Southwest Coastal Design Review / Citizen Advisory Committee Regular Meeting Agenda

STAFF REPORT

Request: Construct deck and staircase and install hot tub in new deck, attached to existing single family dwelling. Requires Major Design Review, per Land and Water Development and Use Ordinance #80-14, Section 4.102 (1)

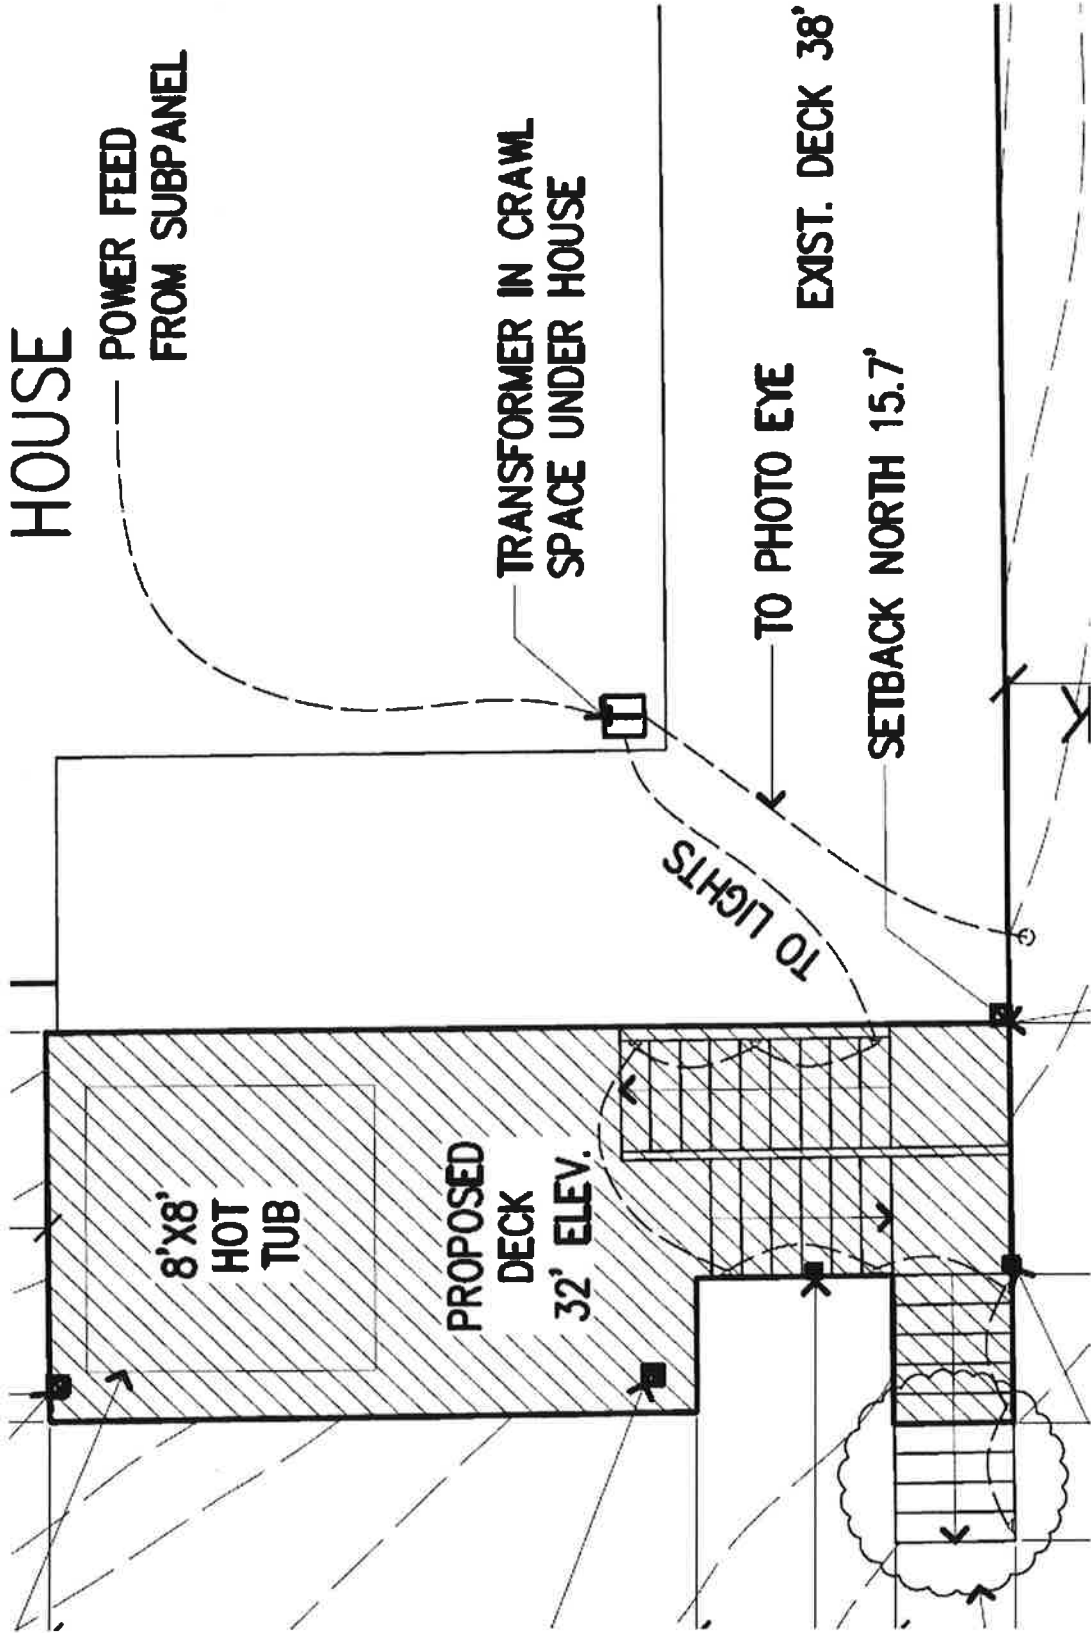
Because the deck will be accessible from the ground, the stairs and landings must to be illuminated to comply with the National Electric Code (NEC). The drawings provided show placement of additional exterior lighting fixtures; however, the lighting plan does not yet have approval from Clatsop County Building Codes regarding the number of foot candles at floor level, so the plan should be considered conceptual at this time.

The fixtures to be used are full cut-off and the plan is designed to light only the stairs and landings. Building Codes may require additional or rearrangement of light fixtures to meet NEC requirements. The building and electrical inspectors are aware of the requirements of the AC-RCR Zone regarding full cut-off fixtures and shielding of glare.

Staff recommends a condition of approval requiring any additional exterior fixtures to be of full-cut-off design and be directed away from neighboring properties and the beach if the committee is comfortable with placing the burden of final review on planning and building staff. If not, the committee may wish to review the final design when it is available.

7. New exterior lighting shall be full cut-off design, and lighting shall be shielded from neighboring properties, the beach and the night sky. Deviation from the concept presented in Exhibit A of this staff report shall be reviewed by the Community Development Director, who may approve or deny the plan or return it to the SCCAC for design review if he believes such review is warranted. "Deviation" shall be understood to mean placement of fixtures more than 18 inches from the surface of the stairs or landings and does not include the number of fixtures.
8. Natural vegetation shall be retained to the maximum extent possible. All work vehicles related to this project shall remain on driveway and any vegetated areas disturbed by this project shall be reseeded or replanted as necessary with 30 days of completion of the project.
